Project: Polk County Welcome Center &
Rest Area Renovation
I-26 Northbound
Columbus, NC

SCO#: 25-30577-01A

Date: March 17, 2026

ADDENDUM #1

3 ATTIC HATCH
SCALE: 1" = 1'-0"

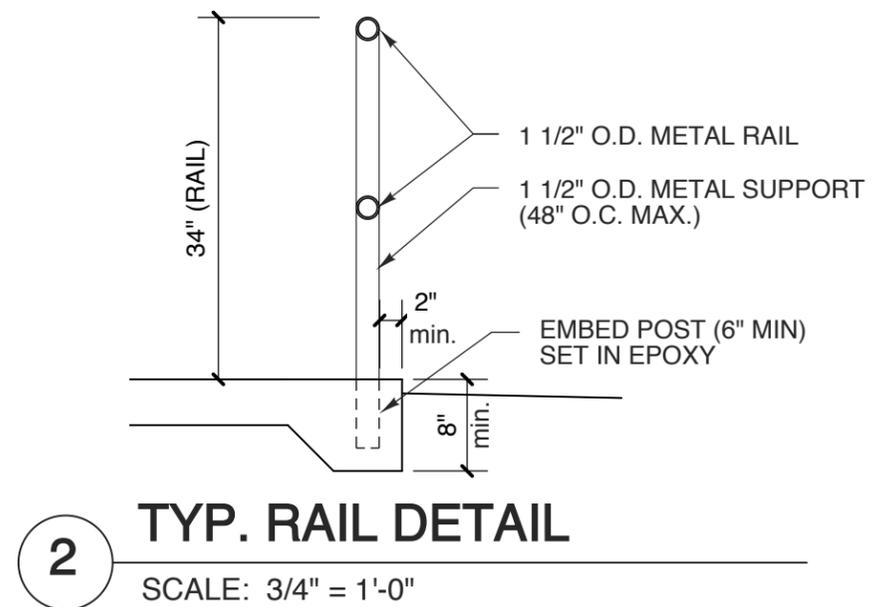
9. Please confirm if any new attic access panels are required buildings. As two existing attic access panels were observed in the drawings.

Yes, please replace the attic access panels in the rest area building only. See attached bulletin drawing for detail.

2 TYP. RAIL DETAIL
SCALE: 3/4" = 1'-0"

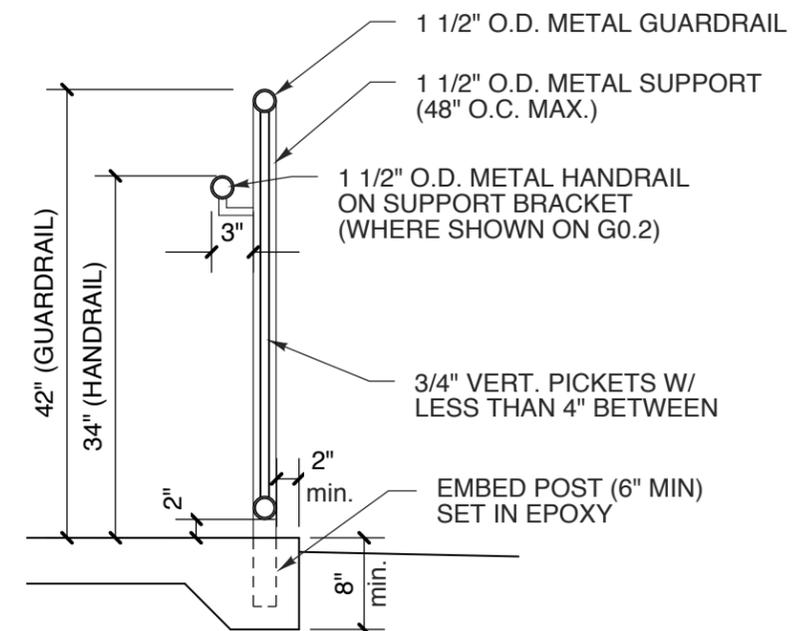
7. On the site layout drawings, the note indicates to replace railing. However, it is not specified whether the existing railing should be reused and reinstalled or if a completely new railing is to be provided. Please confirm whether the new railing needs to meet ADA complaints.

New railing to be provided to replace existing and it shall meet ADA. See attached bulletin drawing for further clarification
